TECHNICAL GUIDANCE NOTE

Fire Risk Assessment of External Cladding Systems on High Rise Residential Building (Phase 3 Report)

Flats 101 – 1303 Iona Tower

Building reference: 158930

Figure 4.1 Provisions for Cavity Barriers

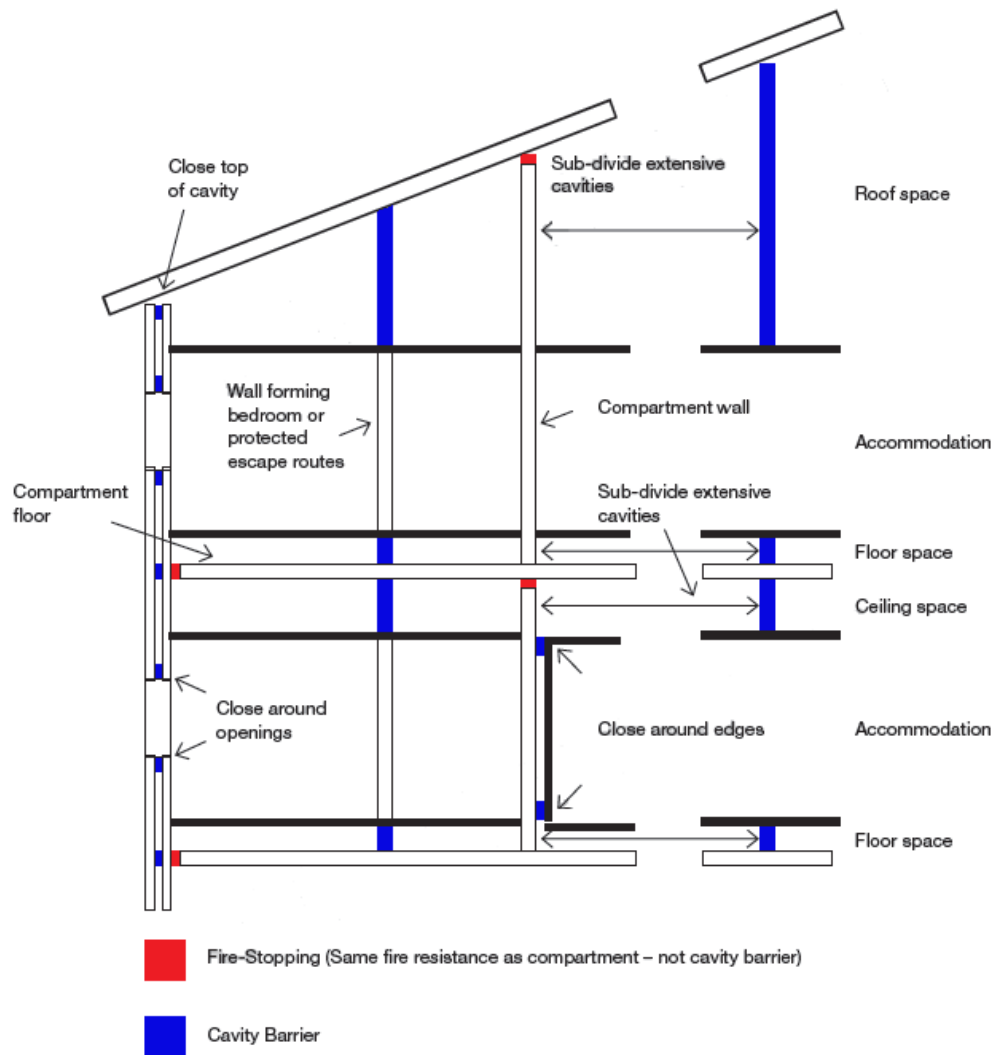
Cavity barriers should be provided in accordance with Diagram 33 overleaf.

A fire barrier was observed between flats where opening up works were carried out, however, the barrier did not extend out through the phenolic foam insulation as provided in the tested detail, nor did it appear to have a cavity closer (e.g. intumescent strip) to close the gap behind the insulation as in the design detail. This requires further opening up to confirm whether a barrier has been provided separating the insulation and providing a means to close the cavity at compartment floor level, and vertically between flats on any of the floors in this building. If a number of sample locations show the same deficiency, all cavity barrier locations will need to be opened up.

The build-up described in the Phase 2 report (Appendix B). This is not consistent with the guidance provided in Approved Document B, since it may render the cavity barrier ineffective by allowing flame to pass around the barrier to the next compartment and beyond, rendering the fire strategy for the building ineffective.

The design detail includes a 20mm cavity with an intumescent strip on the profile to close the cavity behind the cavity barrier. These were not found in all locations where the opening up works were undertaken.

No combustible materials should bridge the cavity barriers, cavity barriers within the rainscreen should have the ability to close the cavity, therefore, all barrier locations should be checked to ensure compliance and that the appropriate level of fire resistance is afforded to the building.

Medium term measures: Provide appropriate cavity barriers to all locations where compartment walls and floors are present and around openings such as windows and doors.
